A G E N D A

Architectural Review Board

March 28, 2023 – 5:30 p.m.

ST

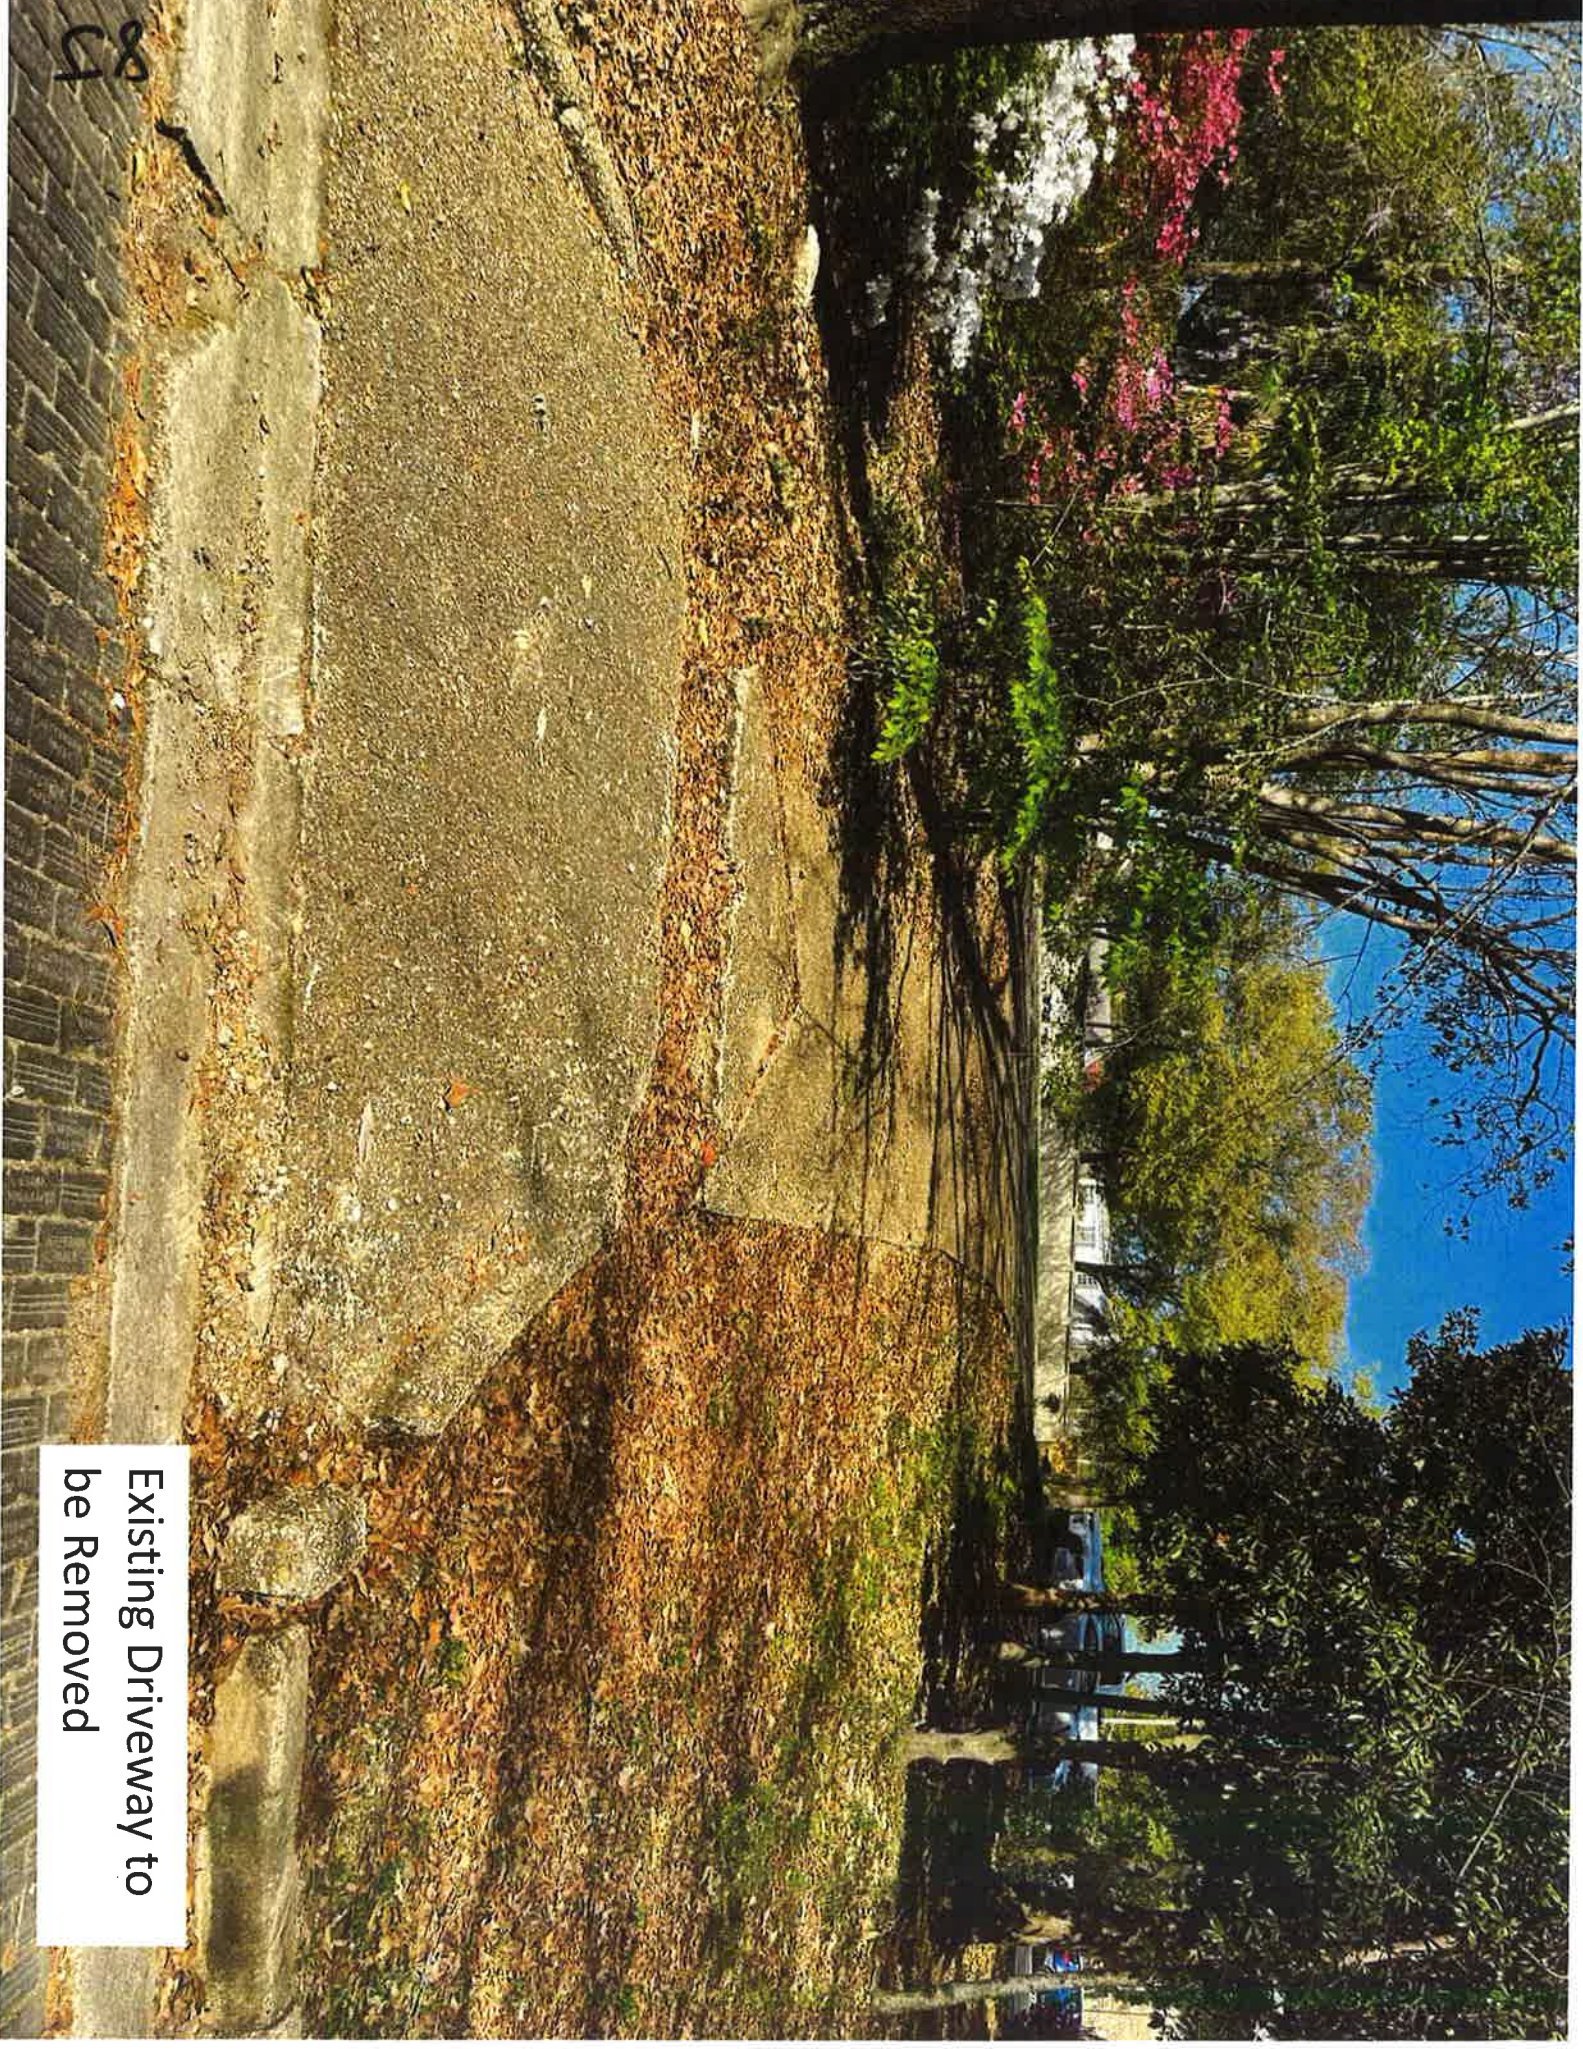
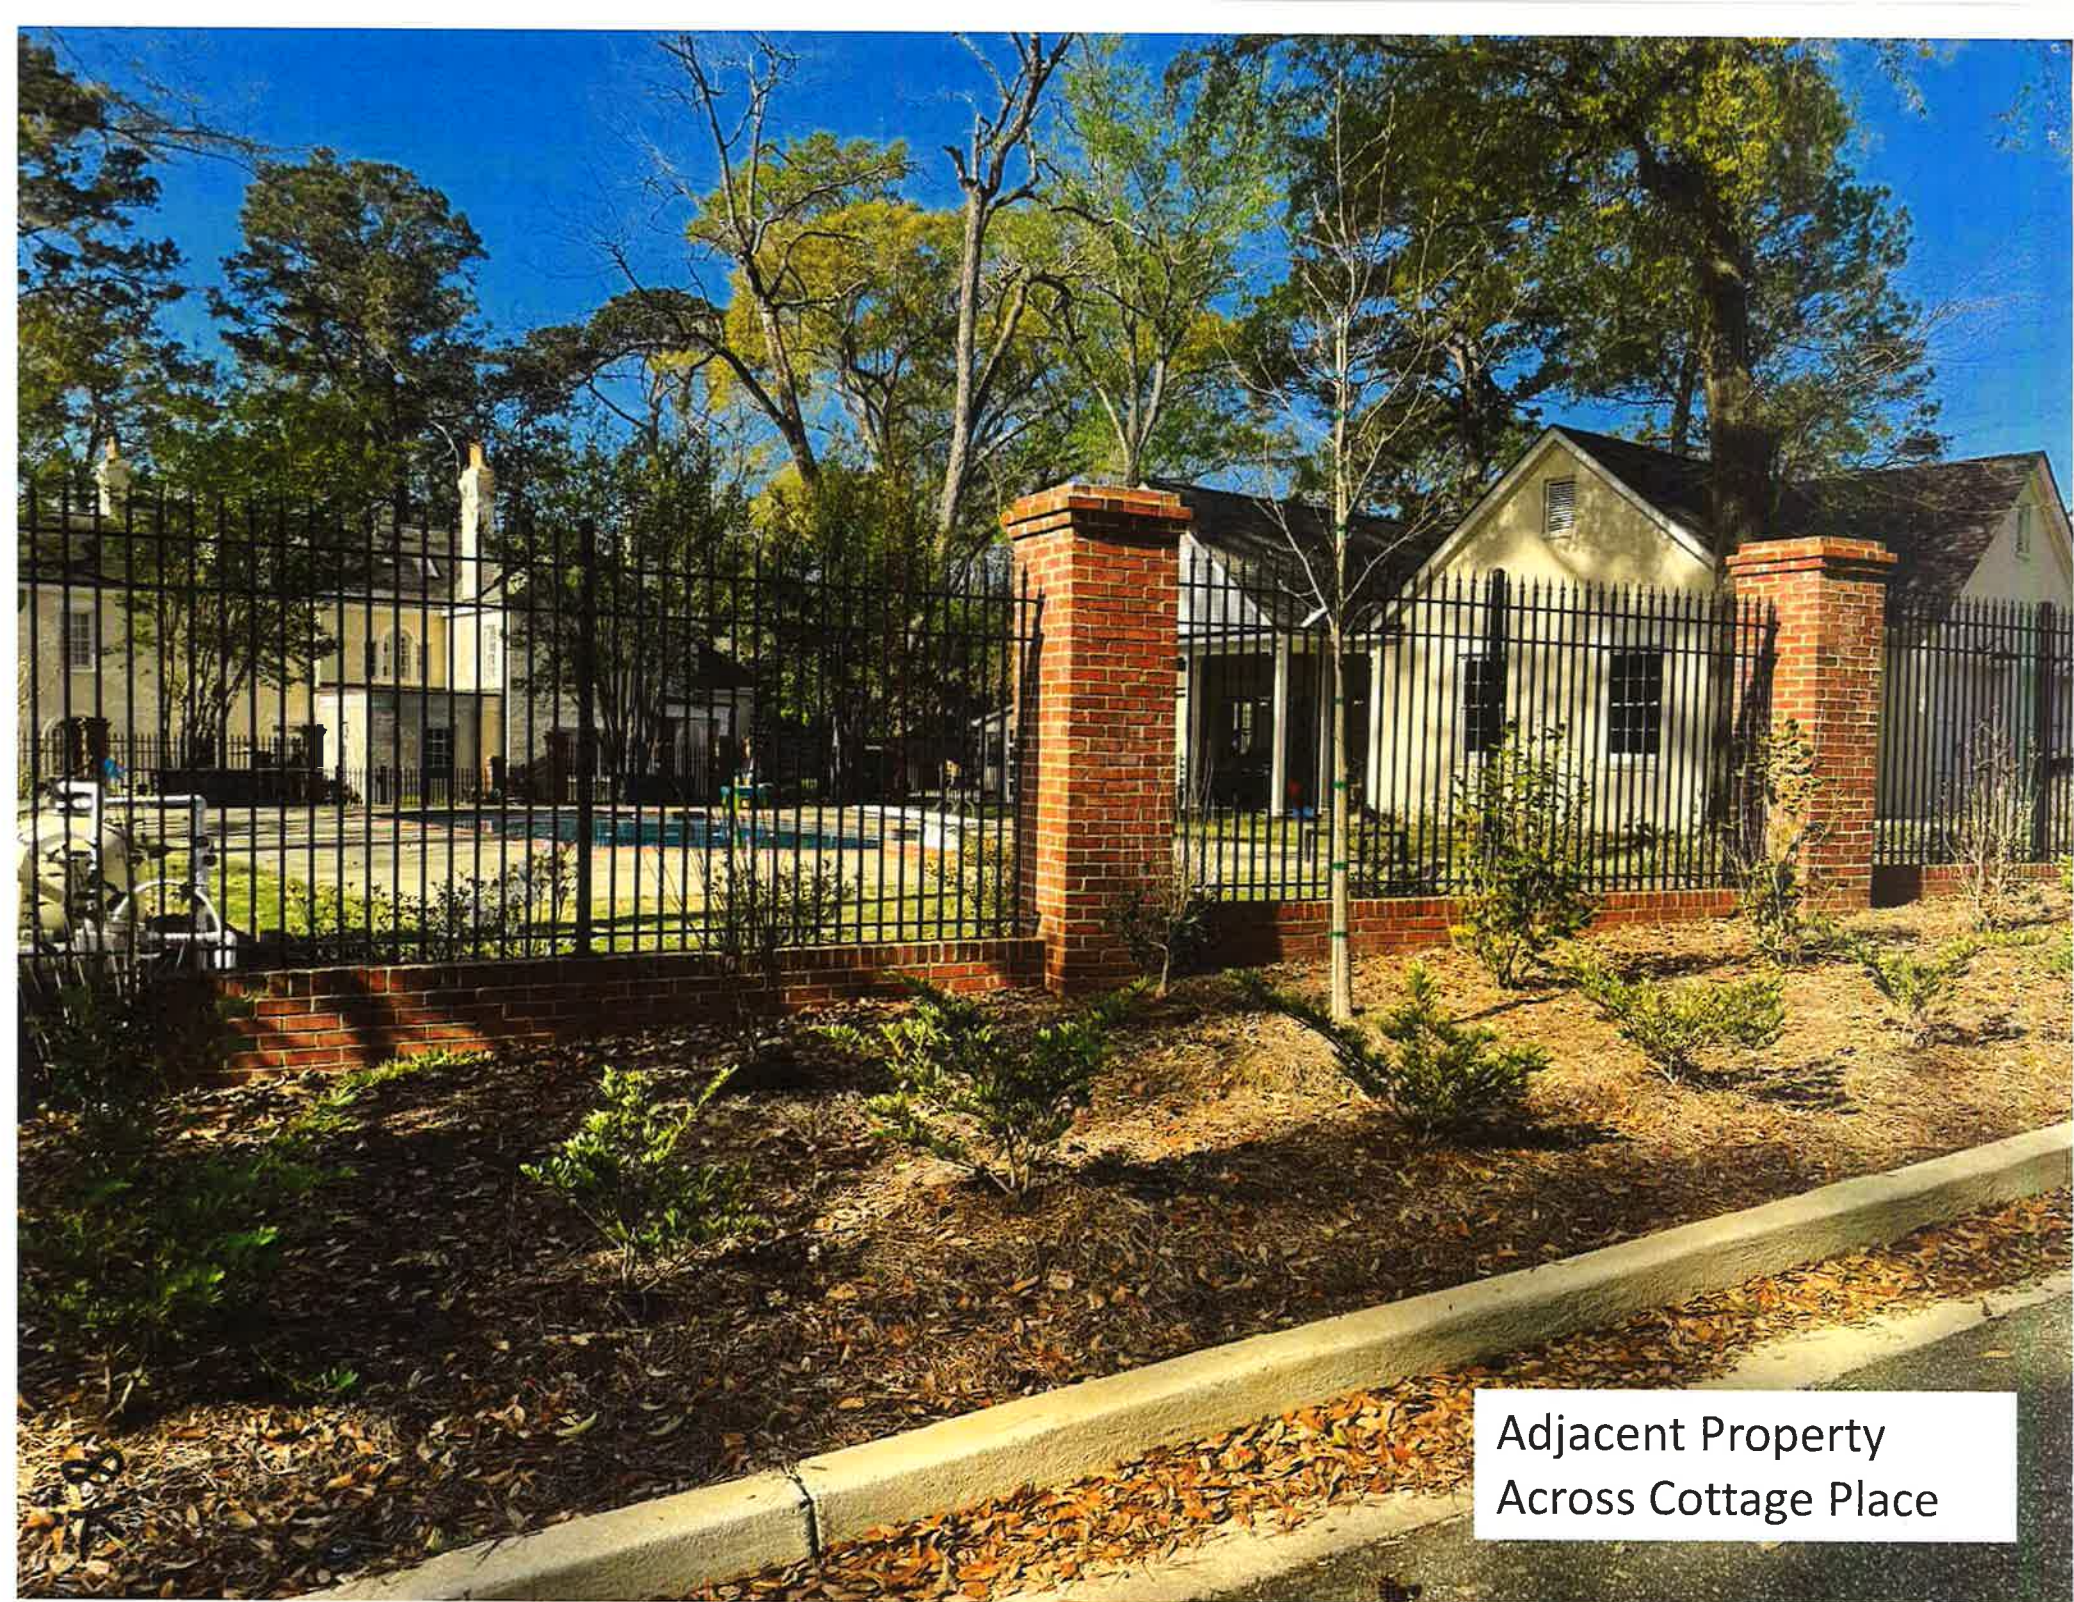
- Parking as proposed will be nearly invisible from the street.
